FILE # # G-17526

PUBLIC INTEREST REVIEW FOR GROUND WATER APPLICATIONS

TO: Water Rights Section Date 6/18/2012
 FROM: Ground Water/Hydrology Section K. Lite
Reviewer's Name
 SUBJECT: Application G- 17526 Supersedes review of 5/21/2012
Date of Review(s)

A. GENERAL INFORMATION: Applicant's Name: Glenn Fessler County: Jefferson

G-17526: Brewer Reservoir and Grizzly Mtn Quadrangles

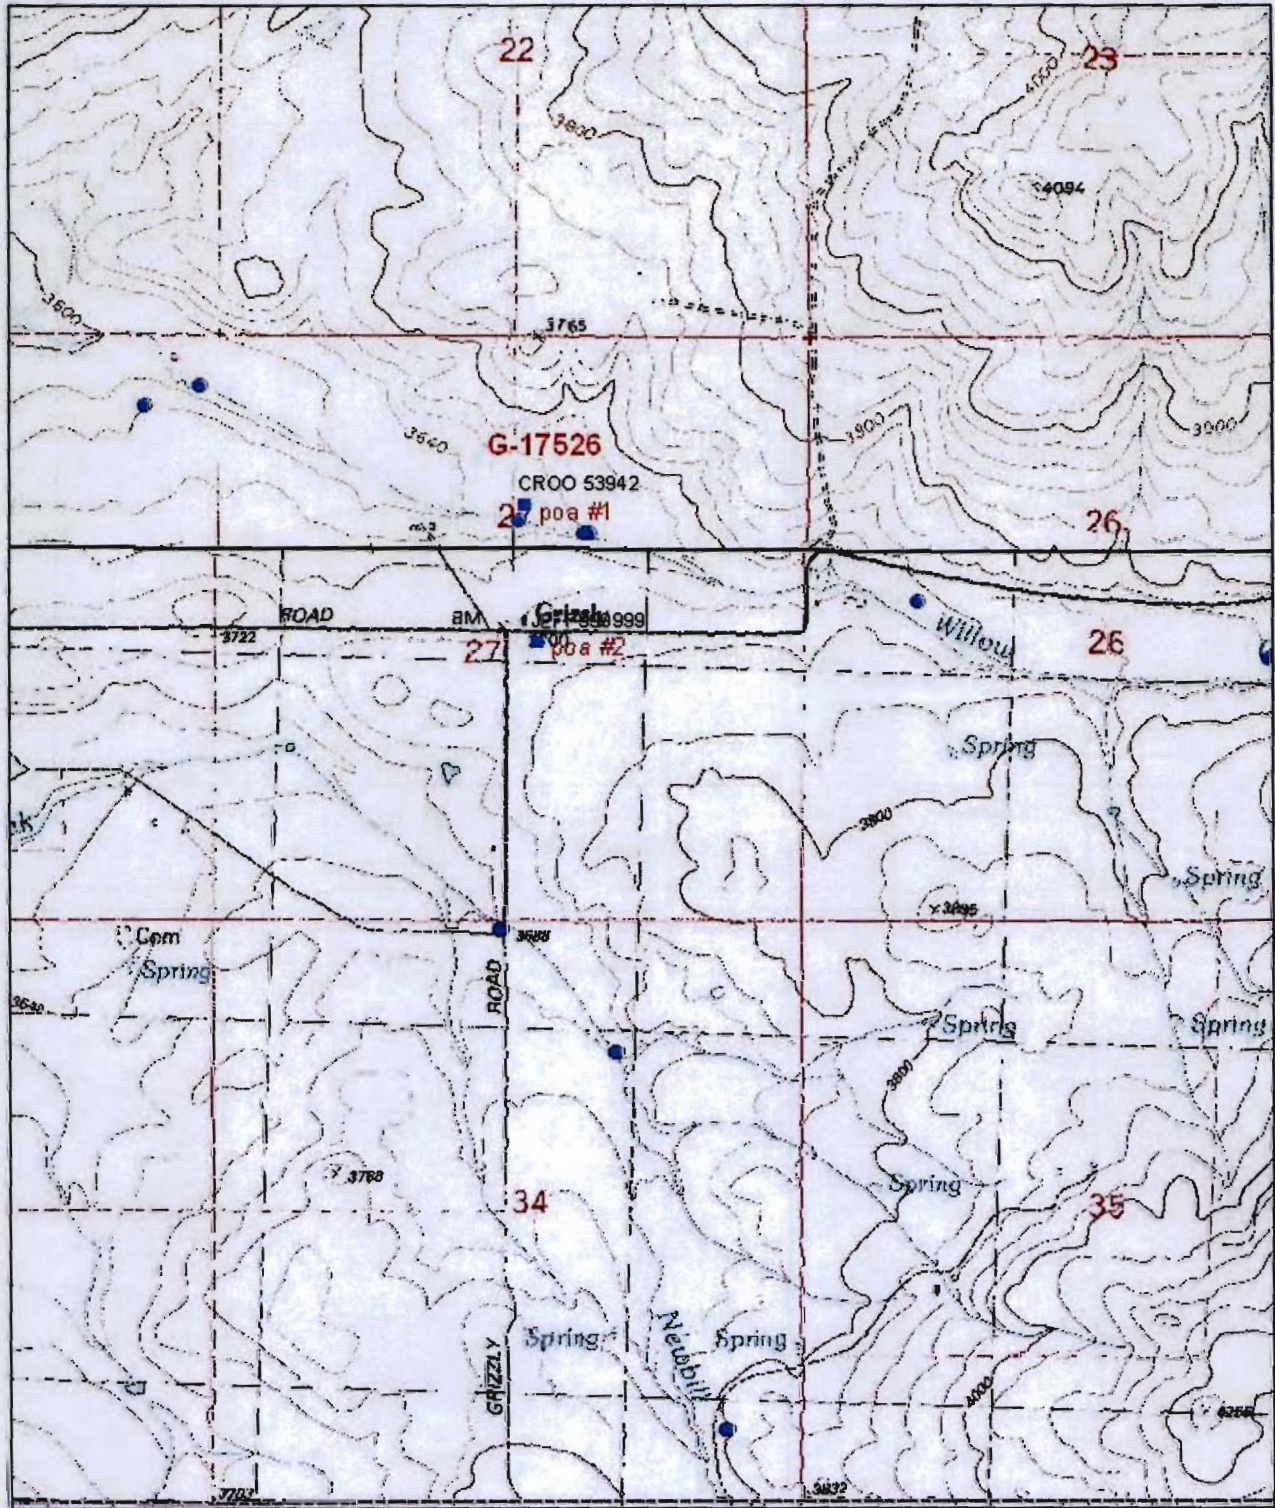
NO NEARBY STATE OBSERVATION WELL IS COMPLETED IN THE CLARNO FM. HOWEVER, THE WATER LEVEL TREND IN A STATE OBSERVATION WELL NEAR MADRAS (OBS WELL 1306 (JEFF 466)), LOCATED ABOUT 12.5 MILES TO THE NORTHWEST IS LIKELY SIMILAR. ALTHOUGH THAT WELL IS COMPLETED IN THE DESCHUTES FM. THE WELL HAS BEEN MONITORED PERIODICALLY SINCE THE MID-1980s. THE GROUND WATER LEVEL HAS SEASONALLY FLUCTUATED ABOUT 1 TO 7 FEET DURING THE PERIOD OF RECORD. CLIMATE INFLUENCE IS APPARENT AT STATE OBS WELL 1306.
